TECHNICAL BULLETIN

[Issue No.] T40-0010

[Title] Additional indications of MELSEC-Q series
CPU serial numbers

[Relevant Models] Basic model QCPUs, High Performance model QCPUs, Process CPUs, and Universal model QCPUs

2. Serial number indication on the front face of the CPU module

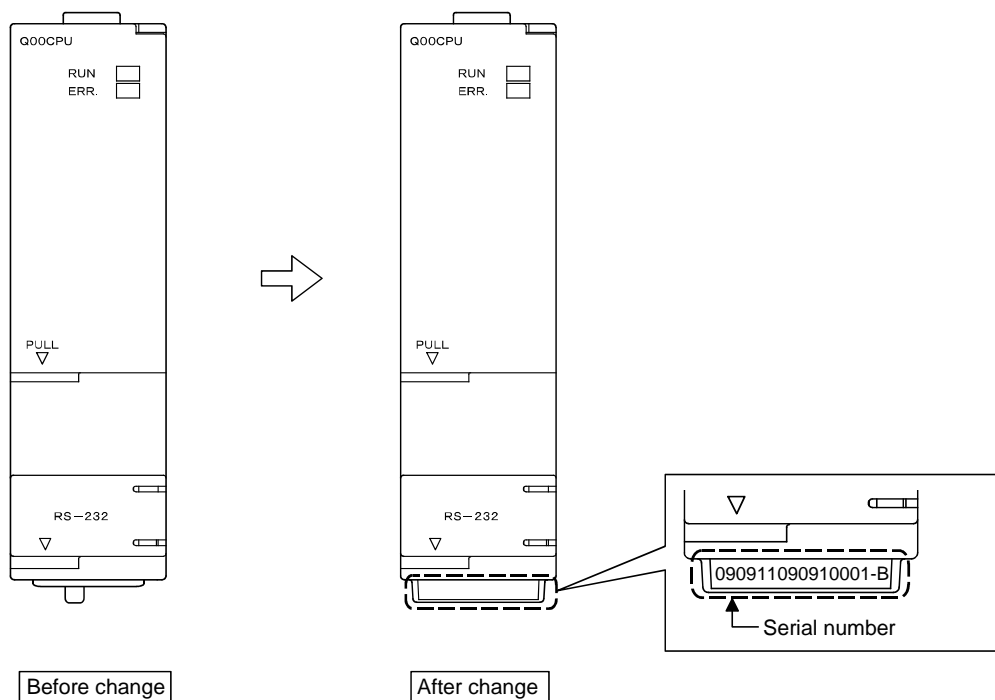
The serial number printed on the side face (rating plate) of the CPU module will be also shown on the front face of the module.

You can identify the serial number without dismounting the module.
